18/8-94A 15200 Barnesville Road
Boyd's Historic District

HISTORIC PRESERVATION COMMISSION STAFF REPORT

Address: 15200 Barnesville Road	Meeting Date: 3/9/94
Resource: Boyds Historic District	Review: HAWP/Alteration
Case Number: 18/8-94A	Tax Credit: Partial
Public Notice: 2/24/94	Report Date: 3/2/94
Applicant: Roy and Frances Haaser	Staff: Nancy Witherell
PROPOSAL: Alterations	RECOMMEND: Approve with Conditions

West side
(EXISTING)

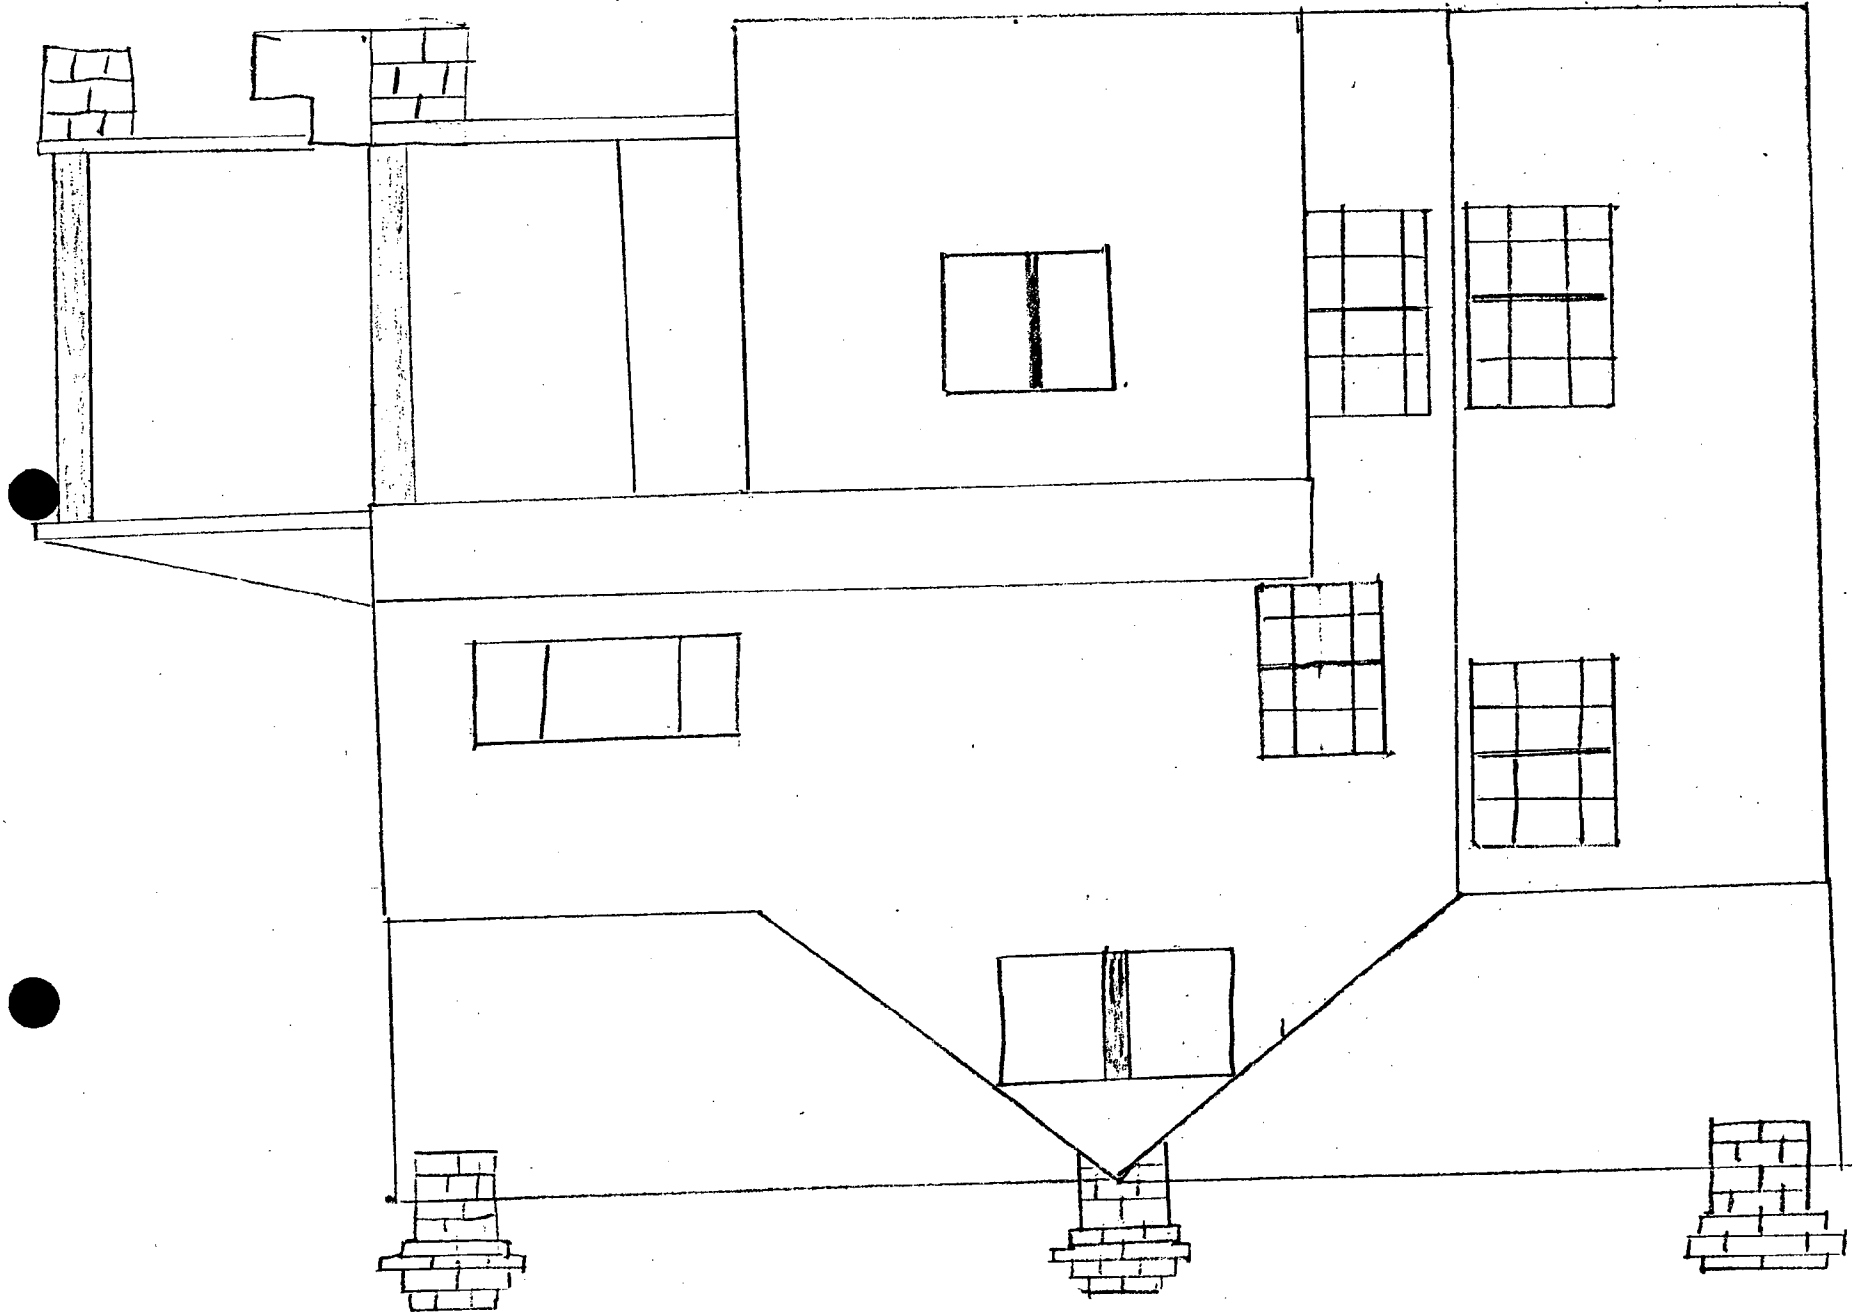
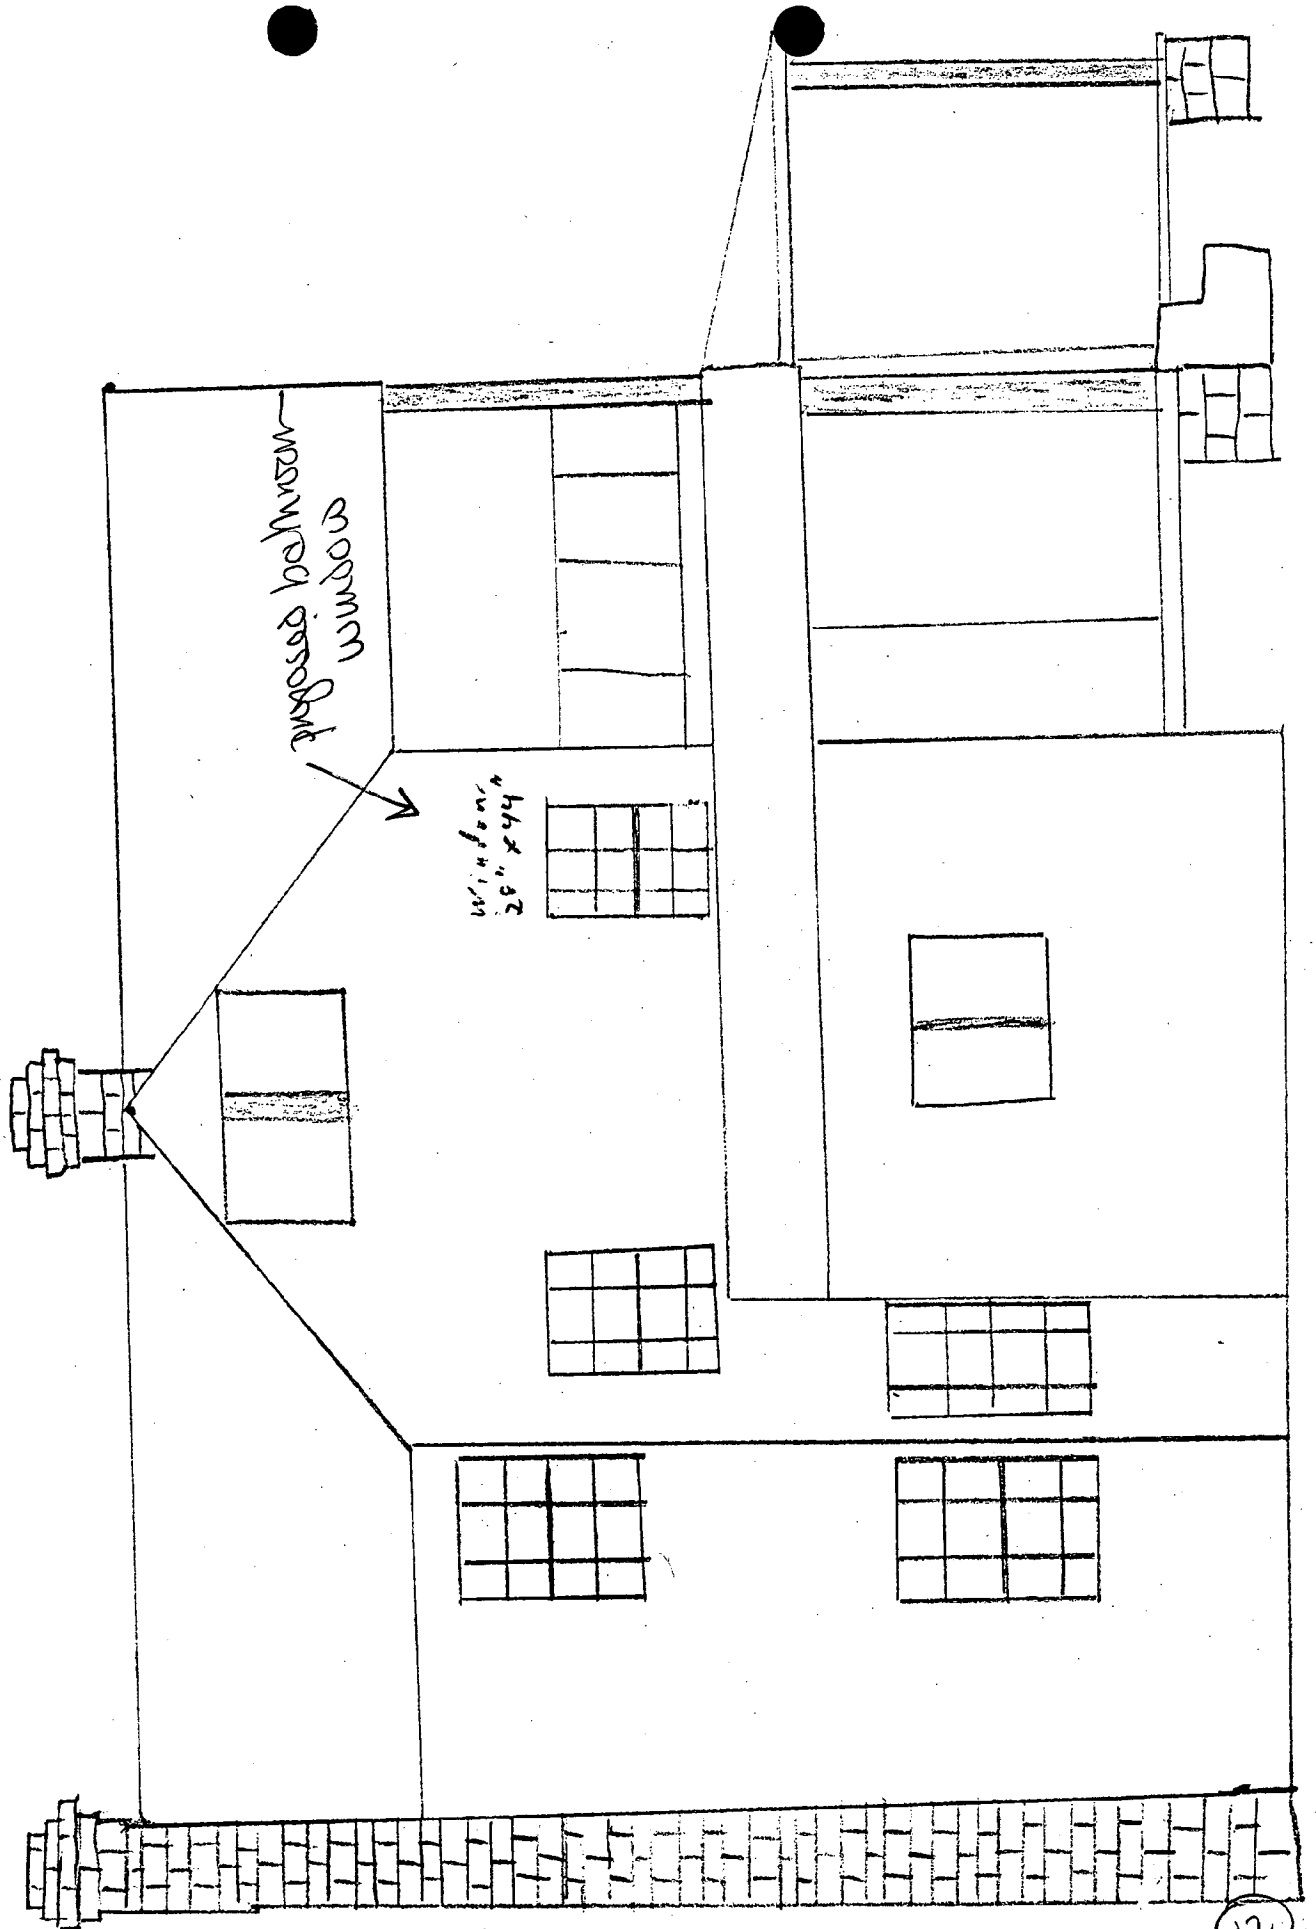
3. Open a bathroom window on the rear elevation, second floor. It would be built to match the other rear double-hung window on the rear elevation.

The size and location of the window should be equal in distance from the corner as the existing window. The window is drawn as a 6/6 sash window and should match the existing windows in muntin profile as well as possible. The staff finds this alteration consistent with the ordinance criteria.

Braces holding south chimney
Braces holding south chimney

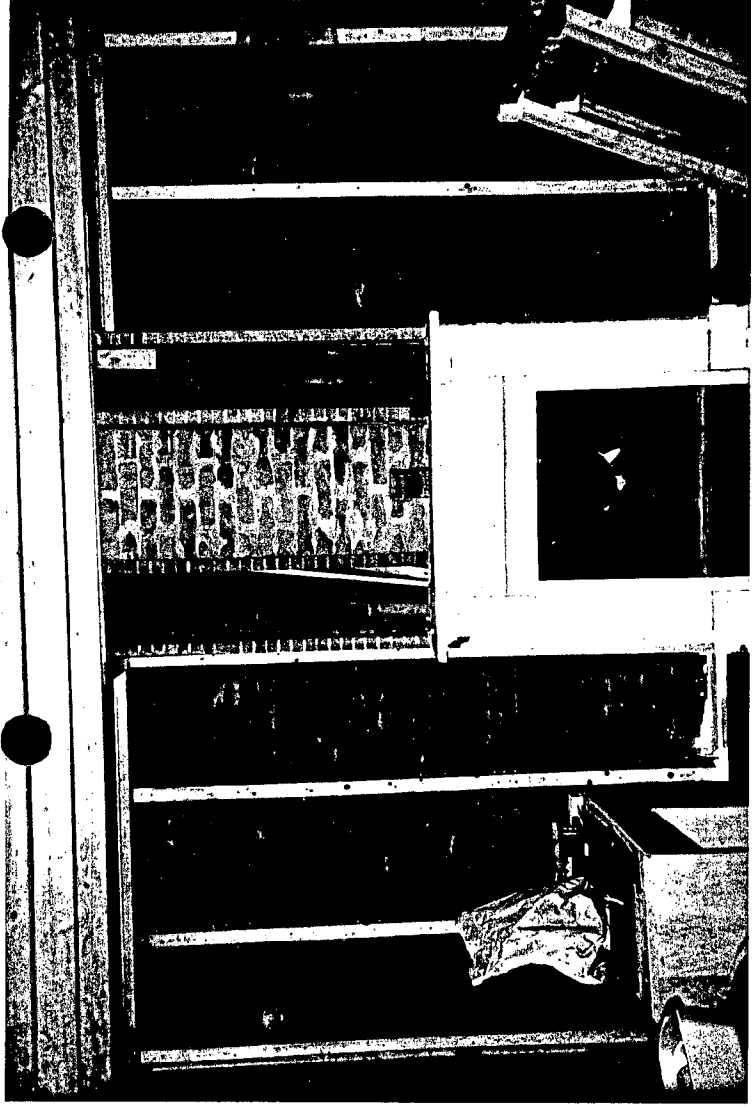
1. Remove upper section of chimney on south (driveway) side because the lower section has been removed. Repair roof to match the existing (metal) roof.

The staff has inspected the chimney and concurs with the applicant that the situation should be remedied. The staff recommends that the chimney be removed.
